# UNITED STATES PATENT AND TRADEMARK OFFICE

APPLICATION NO.	FILING DATE	FIRST NAMED INVENTOR	ATTORNEY DOCKET NO.	CONFIRMATION NO.
10/573,198	03/24/2006	Kazunori Tanaka	Q93230	1919
23373	7590	11/02/2007	EXAMINER	
SUGHRUE MION, PLLC 2100 PENNSYLVANIA AVENUE, N.W. SUITE 800 WASHINGTON, DC 20037			DESAI, NAISHADH N	
		ART UNIT	PAPER NUMBER	
		2834		
		MAIL DATE	DELIVERY MODE	
		11/02/2007	PAPER

<b>Office Action Summary</b>	<b>Application No.</b>	<b>Applicant(s)</b>
	10/573,198	TANAKA ET AL.
	<b>Examiner</b>	<b>Art Unit</b>
	Naishadh N. Desai	2834

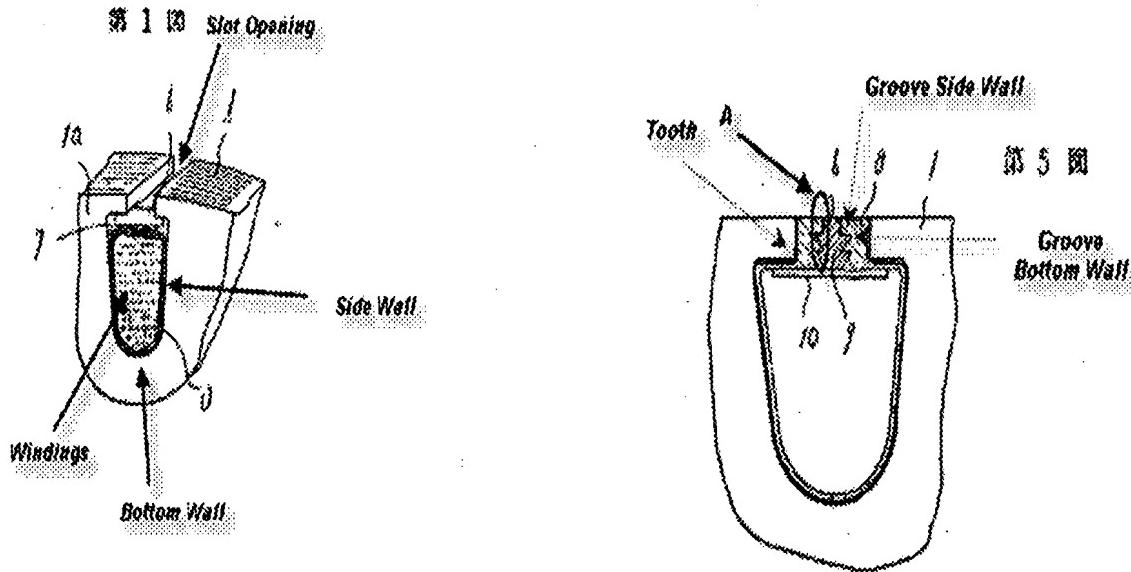
A stator in a rotating electric machine (Fig 1 shows the stator structure of rotating electric machine), the stator comprising(Fig 1,1);  
a stator core(Fig 1,1) provided with plural slots(the abstract speaks of an iron core(element 1) having plural slots) in an inner peripheral surface (Fig 1 shows a stator structure with plural slots in an inner peripheral surface);  
and a stator winding disposed inside each of the plural slots, wherein (Fig 1 shows a stator structure wherein windings are disposed inside the slots);

each slot of the plural slots has a slot peripheral wall (Fig 1, side wall) and a slot opening that opens in the inner peripheral surface (Fig 1, slot opening):

the slot peripheral wall of each slot has a slot bottom wall (Fig 1, bottom wall) and a pair of slot side walls opposing to each other and continuing to the slot bottom wall (Fig 1, side walls are opposing each other and continues to the bottom wall):

the slot peripheral wall is covered with ~~an insulation coating made of an a sprayed powder coating of an~~ electrical insulation material(Fig 1,3 shows an insulation material

covering the slot walls, **also the method of forming or applying the insulation material is not germane to the issue of patentability of the device itself**):

the insulation coating(Fig 1,3 is an insulation material) is formed over continuously from the slot bottom wall to the pair of slot side walls (Fig 1 shows element 3(insulation material) covering continuously from the bottom wall to the slot side walls):

a pair of holding grooves opposing to each other is formed of cuts into in the insulation coating on the pair of slot side walls at the vicinity of the slot opening (Fig 5, 9 shows a pair of grooves opposing each other formed in the insulation(**element 8**) and located by the opening of the slot and between the wedge (element 6). **It also clearly shows the grooves to be formed of cuts into the insulation**):

groove walls of the holding grooves in the pair are formed in the insulation coating(Fig 5 shows the walls of the groove(element 9) to be formed in the insulation member (element 8)) :

and an electrical insulation member for closing the slot opening(Fig 5,10 is a wedge container made of the same material as insulation member(element 8)) is inserted into and held between the holding grooves in the pair(the wedge container is inserted into and held between the holding grooves).

The stator in the rotating electric machine according to Claim 2 1, wherein;  
a depth of each of the holding grooves in the pair is smaller than a thickness of the  
insulation coating (Fig 5, A shows a groove being formed (element 9) having a depth  
which is smaller than the thickness of the insulating member (element 8)).

第 7 図

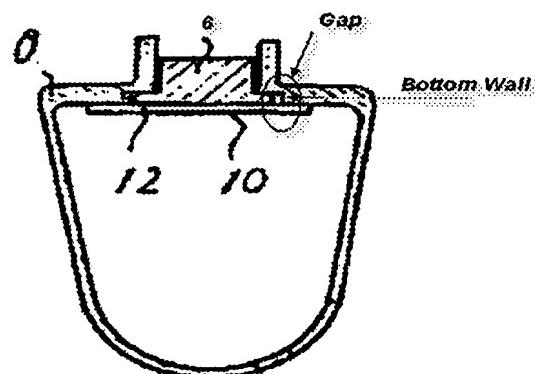
The stator in the rotating electric machine according to Claim 4, wherein a clearance is formed between one of the groove side walls in the pair and the electrical insulation member (Figure 7 shows a clearance or gap formed between one of the groove side walls (the walls of element 11 which is a protrusion) and the insulating member(element 8)).

第 9 図

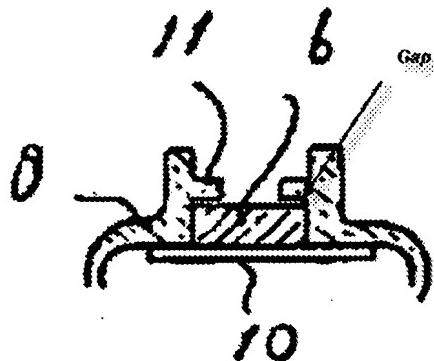
a clearance is formed between the groove bottom wall and the electrical insulation member (Figure 9 shows a gap between the groove bottom wall and the insulation member (element 8)).
